## REMARKS

## AMENDMENTS TO THE DRAWINGS

Fig. 2

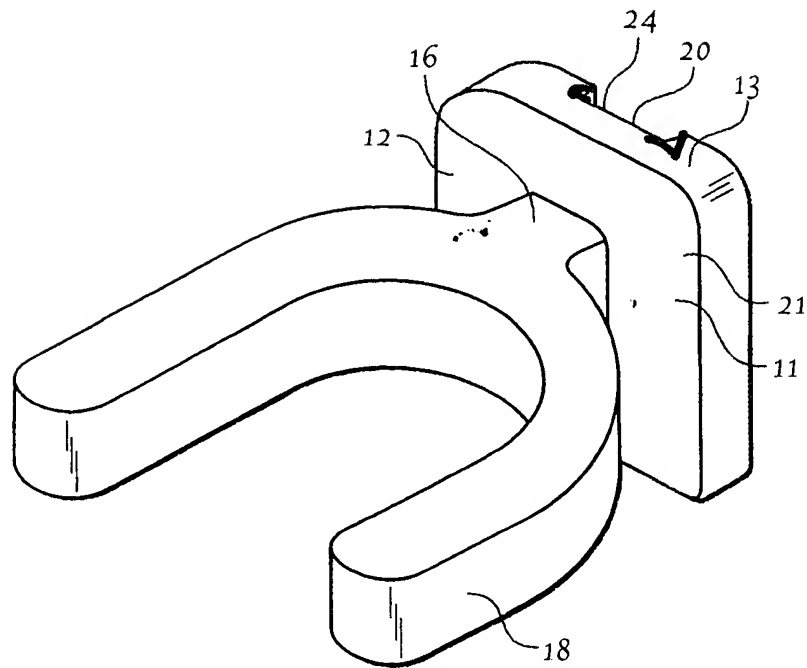
The drawings were objected to as failing to clearly show the cavity being wider at the bottom than at the top. Figures 2, 3, 4, and 5 were stated to appear to not be able to coact together. This amendment presents replacement sheets with amendments to Figures 2, 3, and 5 which clearly show the cavity being wider at the bottom than at the top, and show the sides of the support platform and of the cavity as undercut. The Figures as amended are able to coact together. Basis in the specification for these amendments is at Figures 4 and 6 and at page 6, lines 22-24; page 6, lines 26-27; and page 7, lines 17-19.

Fig. 4

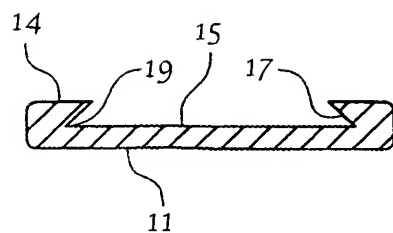
The Examiner stated that Figure 4 did not look consistent with Figures 2 and 3 because Figure 4 shows the sides of the cavity being parallel. Applicants respectfully suggest that Figure 4 is a cross-sectional view taken from Figure 3 and as such has no depth and, cannot show the sides of the cavity being parallel.
